**CHARLES STREET BUS BRIDGE & BUSWAY PROJECT
STAKEHOLDER CONSTRUCTION REFERENCE GROUP WORKSHOP #1
Venue: Main Roads Don Aitken Centre
4:00pm, Tuesday 28th June 2016**

MEETING SUMMARY

6. 15% DESIGN REVIEW

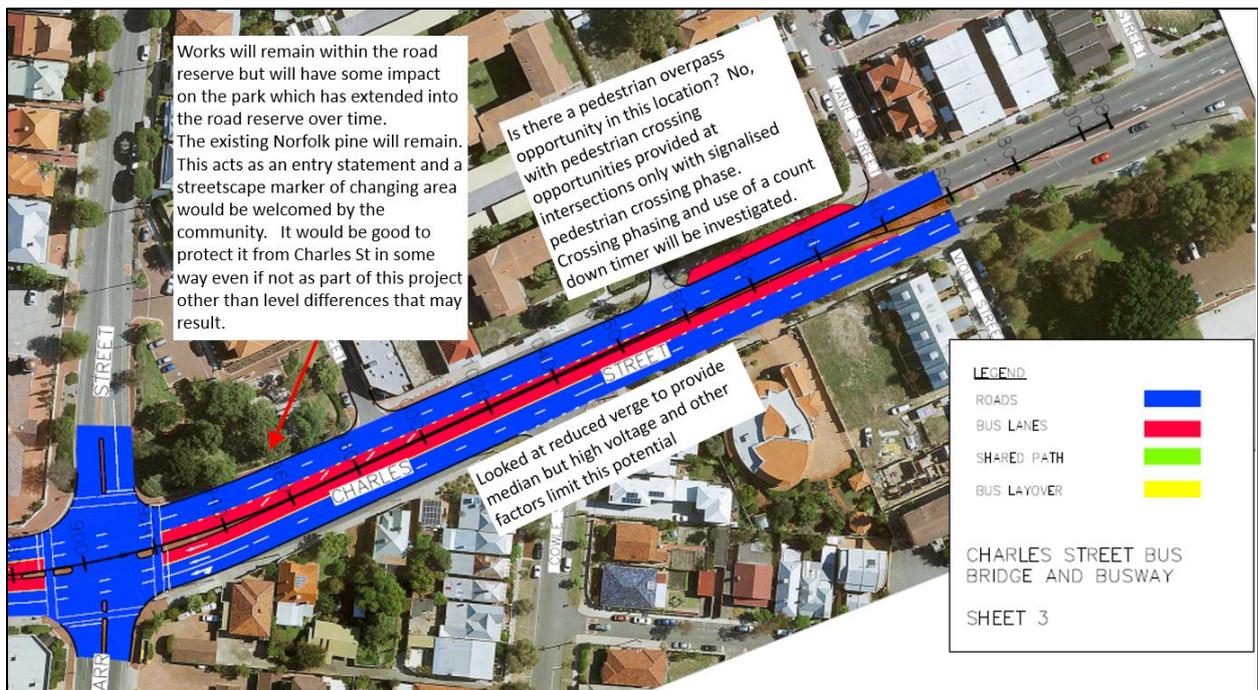
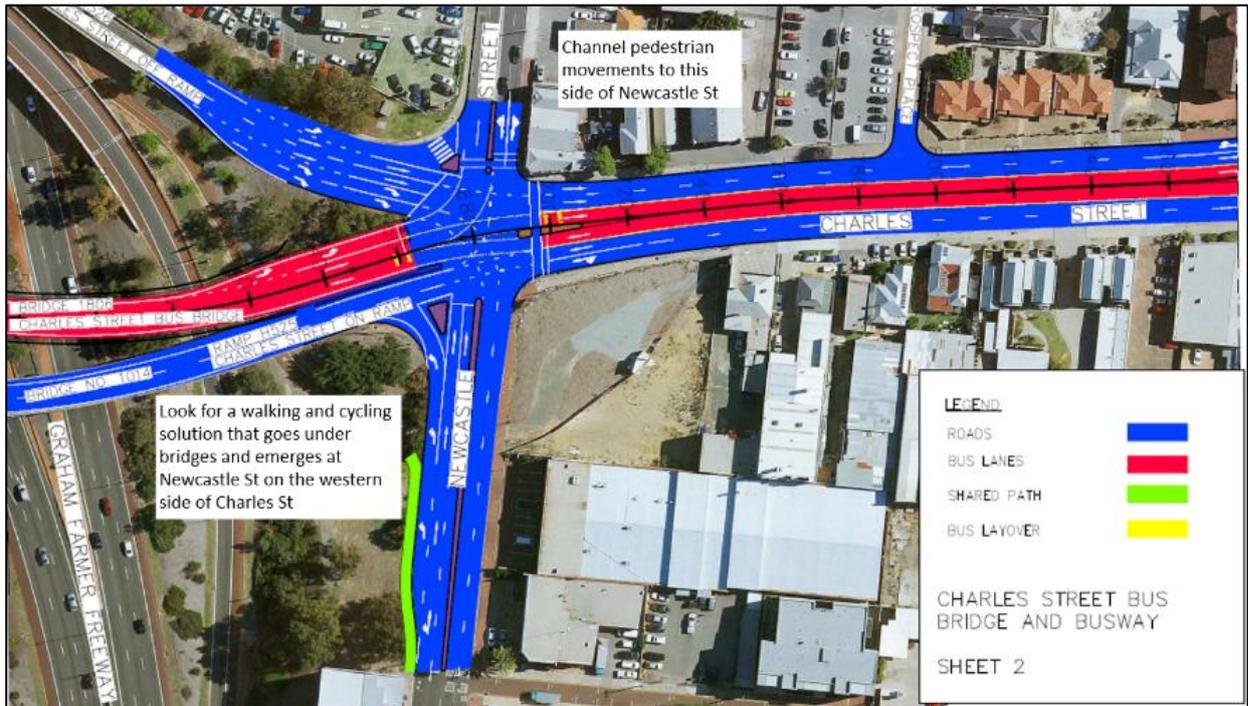
- Provision of right turn movement from Fitzgerald St southbound into Carr St is being investigated, with a Ministerial request to review turning movements at this location. Comment has been sought from Main Roads' Network Operations area. The City of Vincent has provided an interim response for consideration opposing the right turn movement as it will increase traffic on Carr St. Ongoing discussion is needed with City of Vincent input. The current intention is to encourage Fitzgerald St traffic travelling southbound and heading to the freeway to turn right at Newcastle St. Chris Raykos will provide ongoing updates and investigate options noting that CoV does not support it. The SCRG members expressed mixed views about this inclusion.

- Marie Slyth expressed concern at the impacts for Ivy St with car lights and increased crash potential resulting from turning movements.

A number of additional considerations are marked up on the images shown over the page.
